SPECIAL PROVISION (ORNAMENTAL STREET LIGHT)

PROJECT NAME:	BARRE CITY	PLOT DATE:	3/23/2011
PROJECT NUMBER:	FEGC F 026-(K34) C/2	DRAWN BY:	D. PECK
FILE NAME:	z85b010bdr_11_C2	DESIGNED BY:	D. PECK
PROJECT LEADER:	G. BAKOS	CHECKED BY:	
STREET LIGHTING PLAN "I"		SHEET 79	OF 339

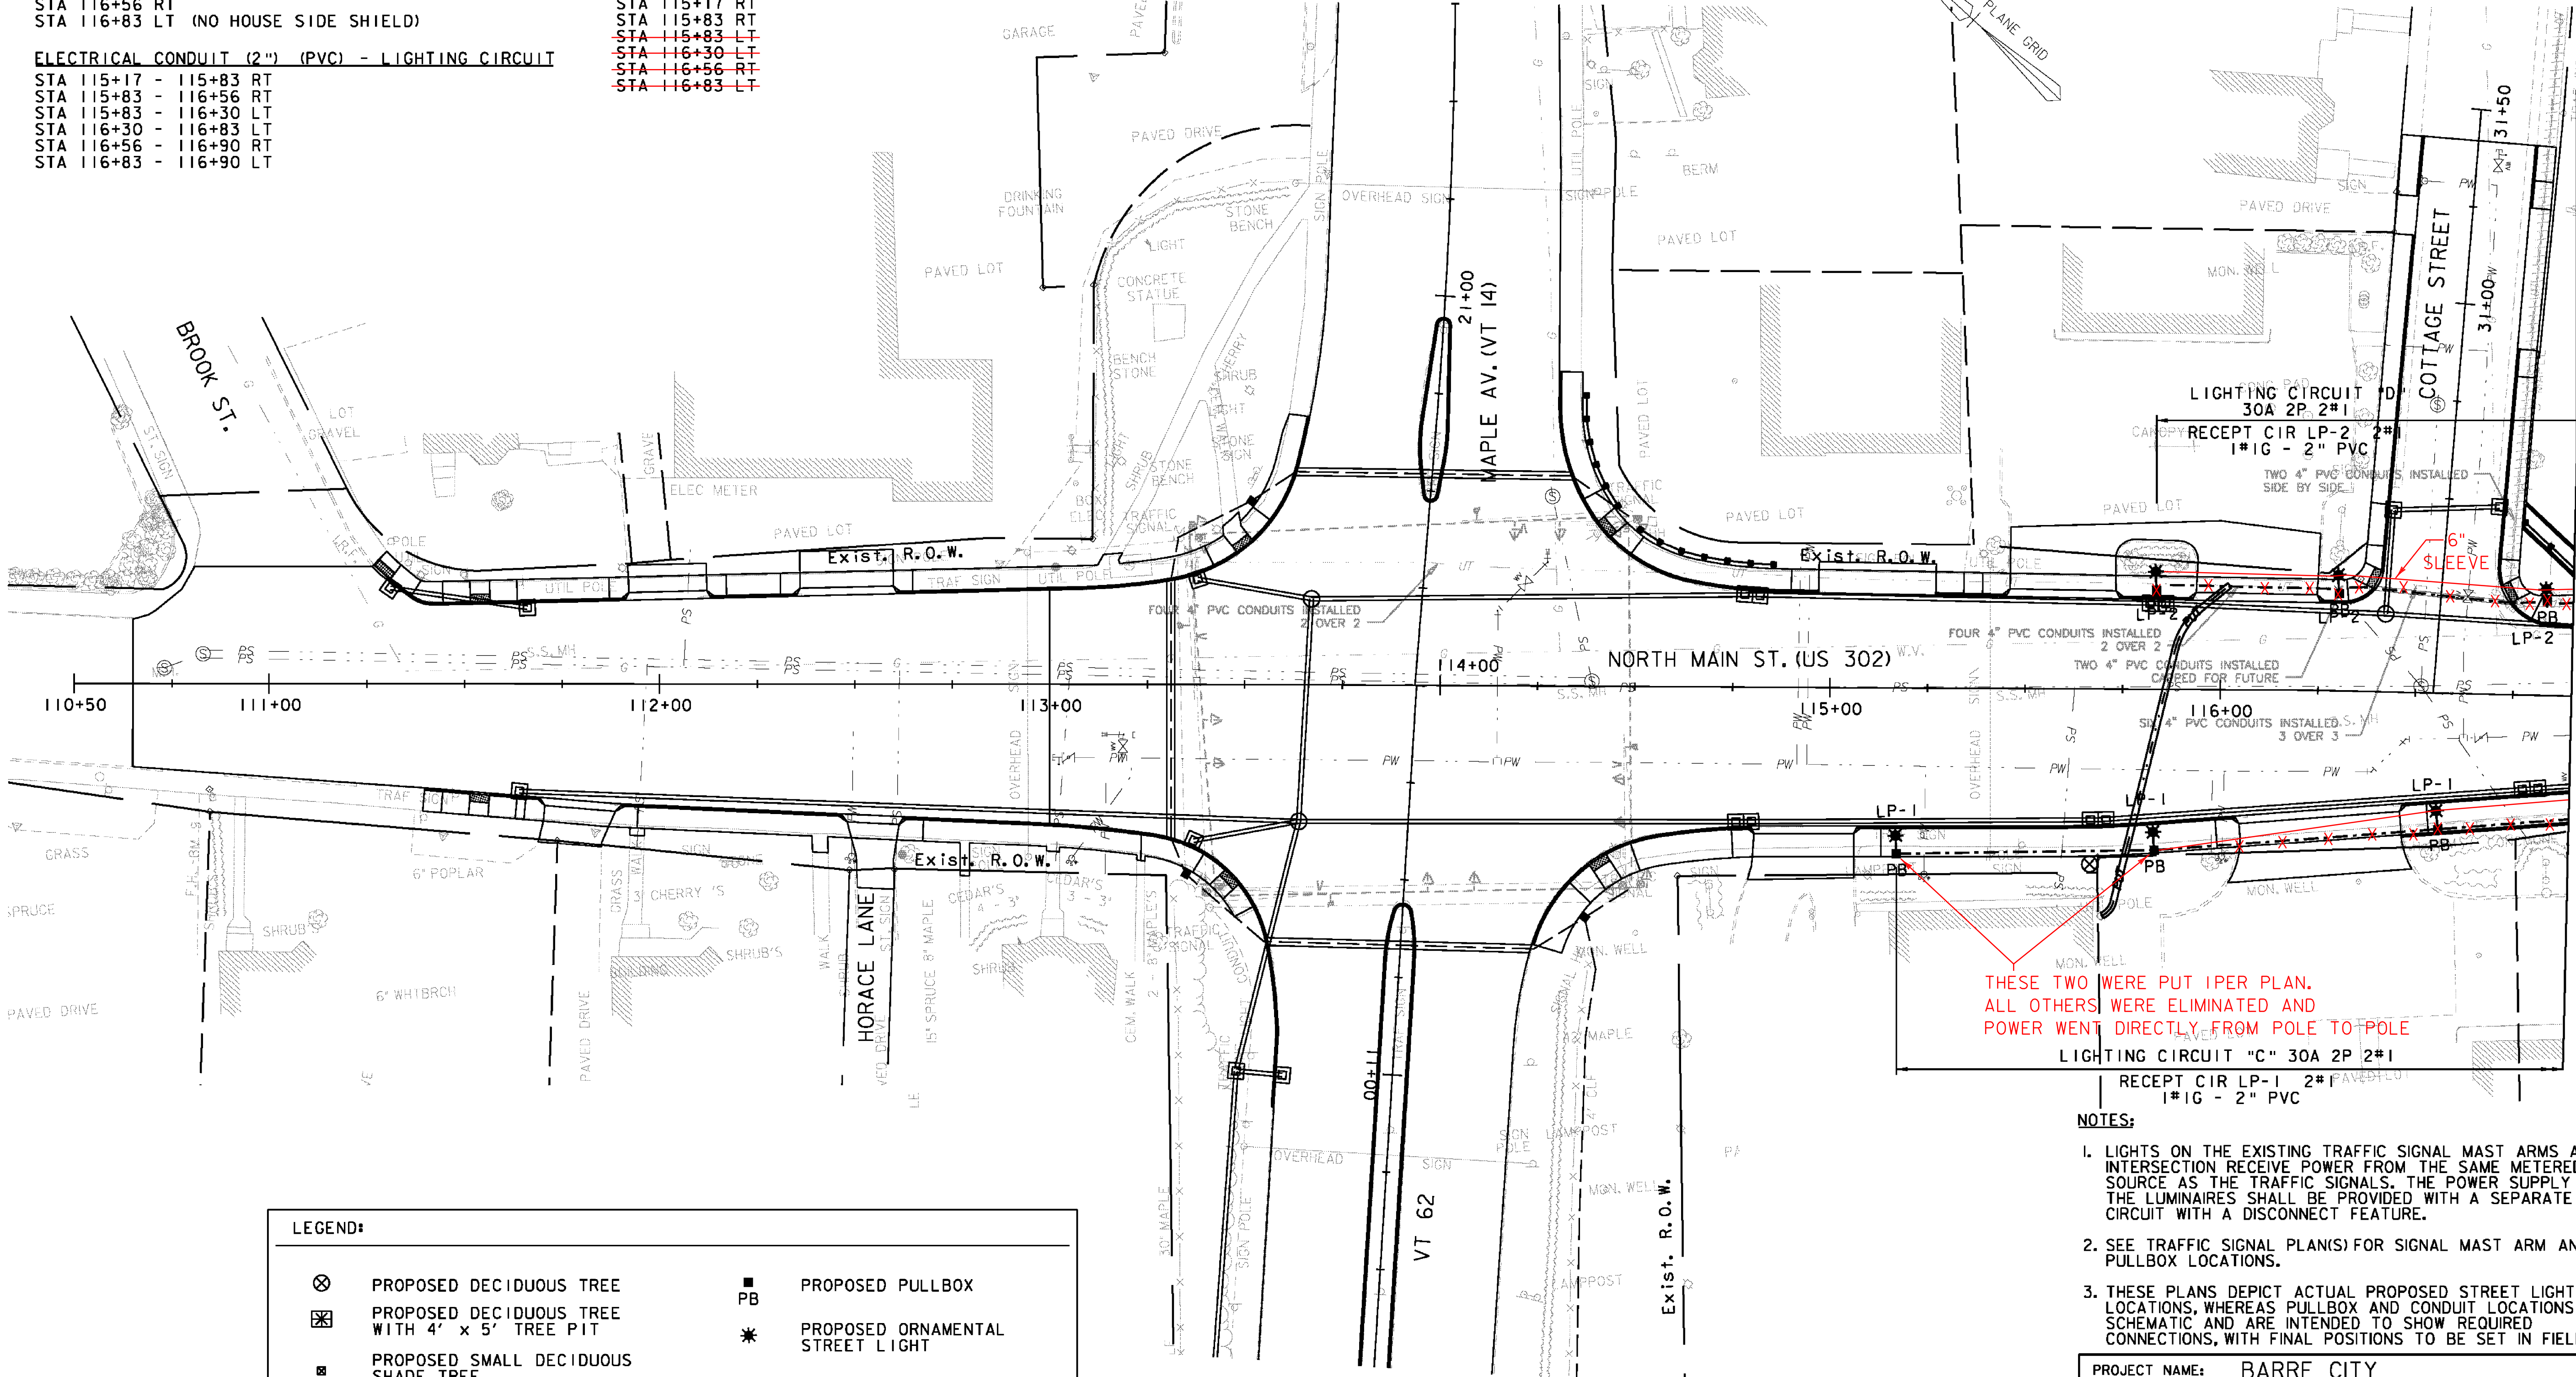
STA 115+17 RT
STA 115+83 RT
~~STA 115+83 LT~~
~~STA 116+30 LT~~
~~STA 116+56 RT~~
~~STA 116+83 LT~~

THESE TWO WERE PUT IPER PLAN.
ALL OTHERS WERE ELIMINATED AND
POWER WENT DIRECTLY FROM POLE TO POLE
